## INA Service Info

# Tensioner pulley 531 0786 10

## for modified engine tuning

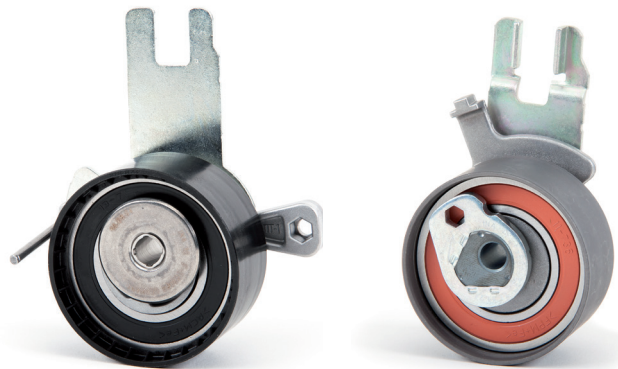
The engine tuning has been modified for the current series of vehicles listed. This can cause the toothed belt to generate noise at certain engine speeds.

Tensioner pulley 531 0786 10 counteracts those noises and therefore replaces tensioner pulley 531 0787 10.

Tensioner pulley 531 0786 10 is already being installed on the affected engines in current production at the factory. The new part can be retrospectively fitted to earlier vehicles listed
